This page lists the know errors on the gm5x5x5 PCBs. There are no known issues with the bulk order run (white pcbs), the following information is valid **only** for the prototype run (green pcbs).

## #1 MIDI IO pins

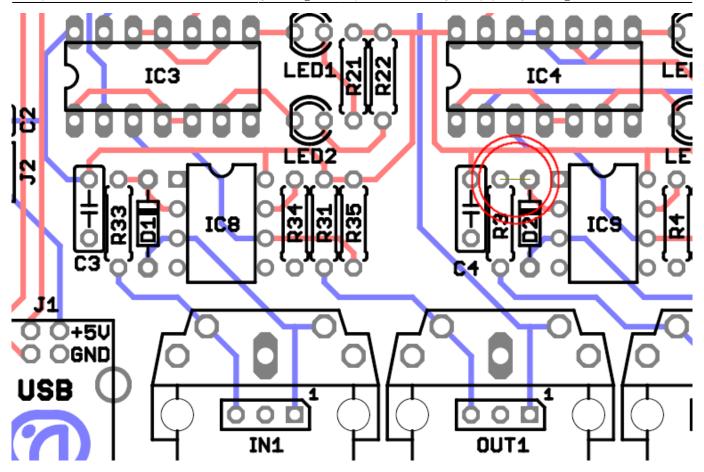
**Problem**: The MIDI IO pins of the midi sockets (Pin 4 + 5) are switched.

**Solution**: Either (1) use the pin-headers if you use sockets that are not mounted on the pcb or (2) break the traces to pins 4 + 5 of the sockets and solder wires to them or (3) solder the midi sockets on the other side of the pcb.
